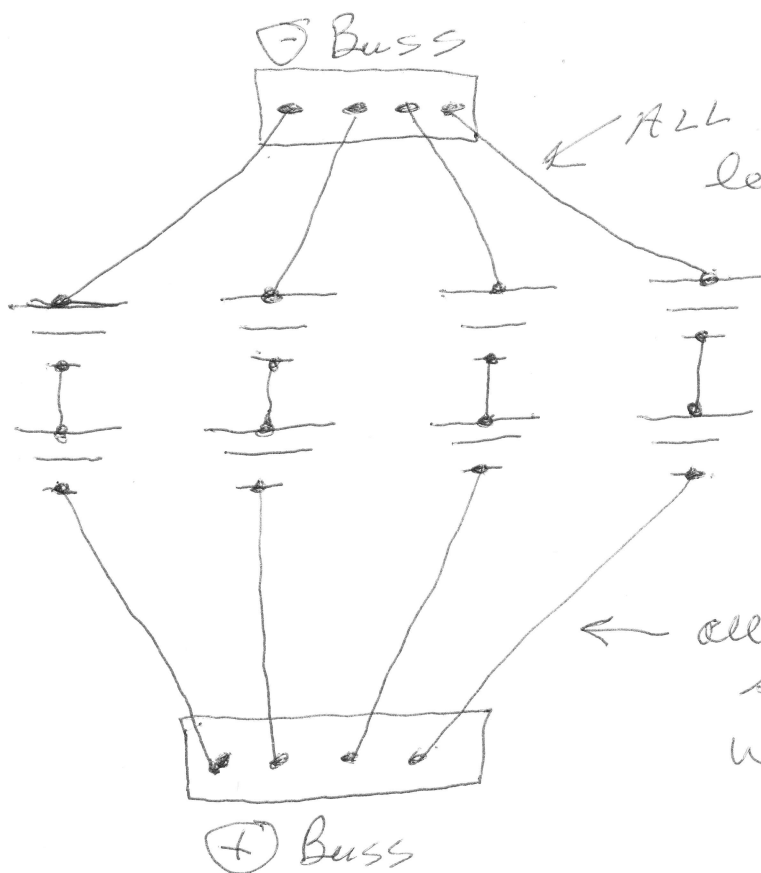
24V But is just
a modified #1 even
if centre connections
are moved so \oplus & \ominus

are not on same battery
set

ALL 4 Batt \ominus LEAD same
length and wire type
and size.

all 4 Batt \oplus leads
same length and
Wire type & size

of course get busses that will
accomodate all the power take offs
and draws. I've only drawn 4 terminals
each. The Busses need to be heavy to
keep interterminal resistance to minimum.
